## **HISTORIC LANDMARKS COMMISSION**

**October 18, 2016**

SUBJECT: REQUEST FOR EXTERIOR ALTERATION EX16-10 AT EXISTING BREWERY AND RESTAURANT TO INSTALL TWO ROLL-UP DOORS, WINDOWS AT VARIOUS LOCATIONS, EXTEND DECKING, ADD SOLAR PANELS, ADD POP-UP ON LOWER ROOF, AND RESTORE HISTORIC SIGN

Potential sign restoration-siding for removal

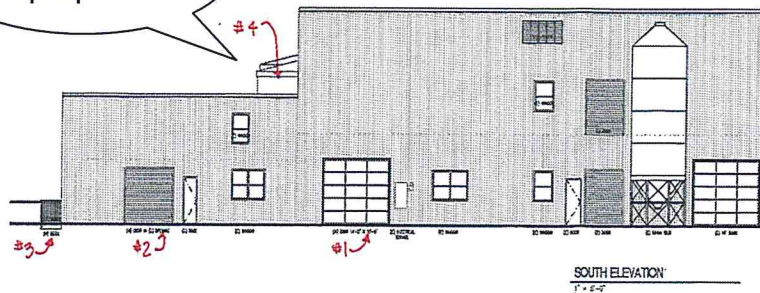
Finding: No alterations are proposed to create an earlier appearance. Siding is proposed to be removed to inspect the condition and potential to repair and restore the “New England Fish Company of Oregon” sign. Should restoration be feasible, the applicant shall submit a sign permit with the Community Development Department.

1. Significant changes or modifications to the proposed plans as described in this Staff Report shall be reviewed by the Historic Landmarks Commission.
2. The applicant shall submit a sign permit and documentation for restoration work for a certificate of appropriateness or higher level of review depending on the condition of the sign once the siding is removed.
3. Should the design of the solar panels alter from what is reviewed by the HLC, additional review by the Community Development Department and possibly the HLC may be necessary prior to installation.
4. An updated elevation certificate, and if necessary, FEMA Flood Insurance Certificate shall be submitted by the applicant for pre and post-construction.
5. Additional details for the maintenance on the west deck is required. The applicant shall submit necessary documentation for review by the Community Development Department.

*a. Roof mounted Facilities:*

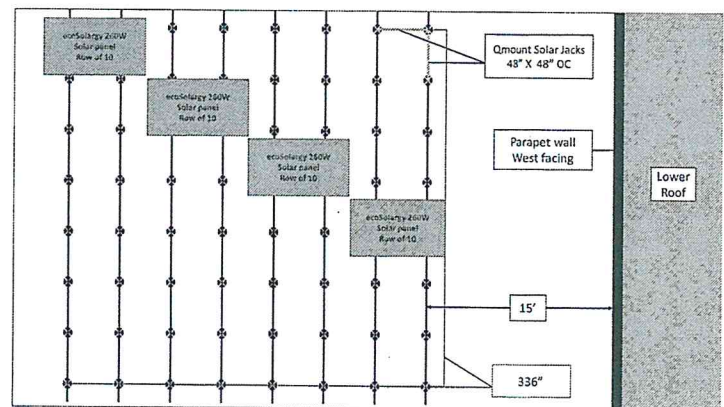
A site plan is below. At the time of the exterior alteration submission, the solar permit form was incomplete. Prior to installation, the applicant shall submit the required building permits to install the proposed solar panels.

- The applicant indicated the total roof area for the structure including the new pop-up design is 21,591 square feet, 2,600 square feet is proposed for paneling, which is less than 25% of the roof area on which they are located. The panels will generate power for the structure, are not on a primary elevation and will be hidden from view by the parapet wall. For both Section 6.050(D) (5) and 16.030 (3), the criteria for the solar panels has been met.

Proposed doors and windows

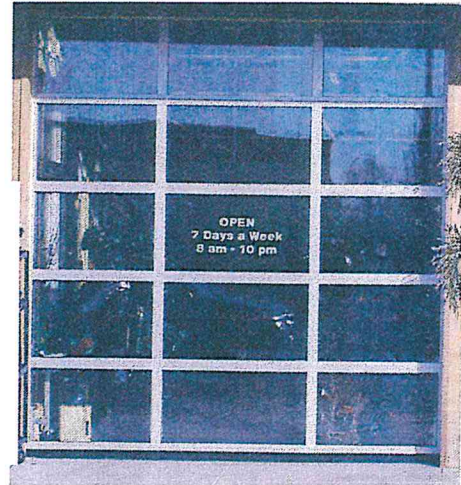
Finding: No architectural features are proposed to be replaced. The industrial cannery style will be retained on the exterior; the treatment of the windows and doors will be similar as previously installations.

The proposed doors are aluminum sectional doors to match the existing roll-up door. The size and scale

match the most recently installed doors during the last remodel, and will maintain a compatible design. The larger roll up door is 14' x 10', with five panels, similar to the existing doors in the tap room and brewing room. The smaller door is 10' x 8'-5" with metal coiling. It is similar to the existing solid metal door used for material access.

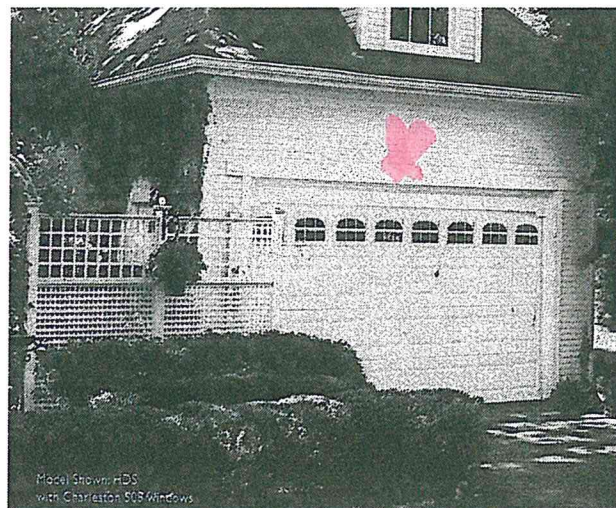
The proposed garage door consists of short panels and eight small windows. The materials are hot dipped galvanized steel skin and a woodgrain texture raised panel design which is paintable to match the single family dwelling. Wood grained textures are usually discouraged for both siding and any paneling, as it often intends to recreate a historic look or faux texture. The size and door style is appropriate for the needs of the garage; however the applicant shall propose alternative materials for review.

1. Significant changes or modifications to the proposed plans as described in this Staff Report shall be reviewed by the Historic Landmarks Commission.
2. The applicant shall obtain a grading and erosion control permit from Public Works Department.
3. The applicant shall submit for any necessary electrical permits to Clatsop County.
4. The applicant shall be responsible for returning the existing gravel alley to an equal or better condition upon completion of construction of the garage/driveway
5. All lites in any doors and windows shall be true divided.
6. Wood grained textures are usually discouraged for both siding and any paneling. The applicant shall propose alternative materials for review.

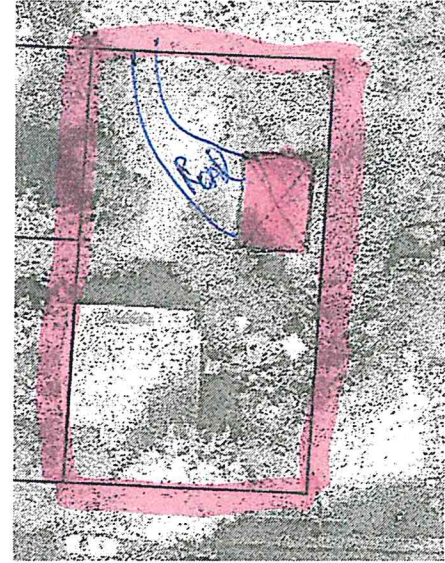
for the R-2 zone. The applicant has been approved for a variance (V16-08) from this setback, to locate the garage within the setback in order to avoid cutting down trees. The east side of the lot is adjacent to unimproved right of way, and the Astoria Transportation System Plan does not indicate planned transportation system improvements to this segment of 37<sup>th</sup> Street.

Any changes in the location of the building shall be reviewed and approved by the Planner prior to issuance of a building permit.
